Page #8

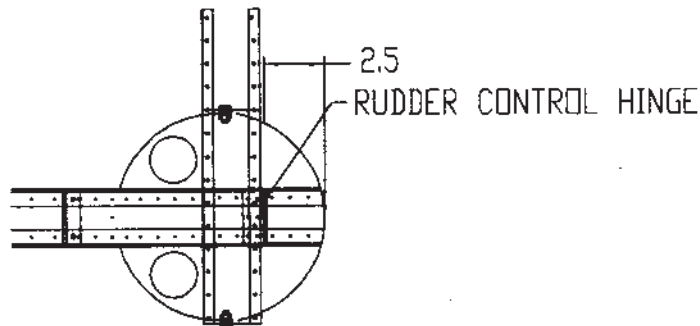
1. Changed rivet spacing on rear spar from 2" to 1".
2. Added throws for Ailerons. 30° up and 15° down.
3. Changed note for the lower rails to read that they can be 3/4 x 3/4 x 1/16 6061T6. For economical reasons.
4. Changed the width of the "rough landing doubler" to 9" and changed rivet spacing along ribs to 1".

5. Changed note for attaching the outer panel rear spars to read "use Type 1-8 rivets" instead of avex rivets.

Page #9

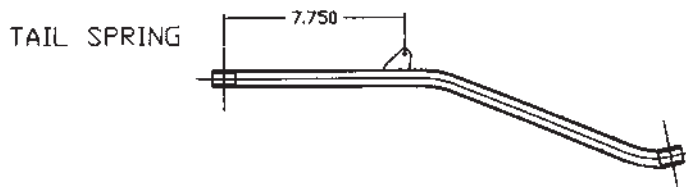
1. Added elevator and rudder throws. Rudder is 30° both ways.
Elevator is 25° up and 15° down.
2. Changed dimension for the rudder control hinge from 2.562 to 2.5.

3. Changed dimension for the tail spring mounting holes (was 7.375).

4. Changed dimension for the length of vertical spar to 42" .
